Adding CE Mark on Batteries for AC Servo Amplifiers in Compliance with EU Battery Regulation

Date of issue	June 2024	Title	Adding CE Mark on Batteries for AC Servo Amplifiers in Compliance with EU Battery Regulation	Mitsubishi Electric Corp., Nagoya Works 1-14, Yada-minami 5-chome, Higashi-ku, Nagoya 461-8670 Tel.: +81 (52) 721-2111 Main line
----------------------	-----------	--------------	--	--

Model	Before	After
MR-BAT6V1SET(-□) MR-BAT6V1 MR-BAT6V1BJ

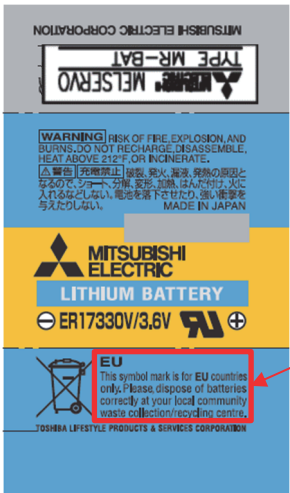
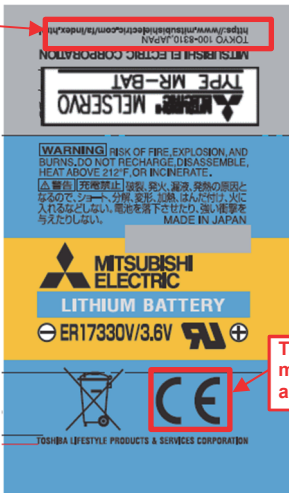
Built-in batteries will bear the CE mark.

In terms of the restrictions on substances in the EU Battery Regulation, the substances contained in the batteries have been all under the regulated values.

The components of the batteries are the same before and after the change.

This change will only involve the bearing of the CE mark and does not affect the functions and performance of the products.
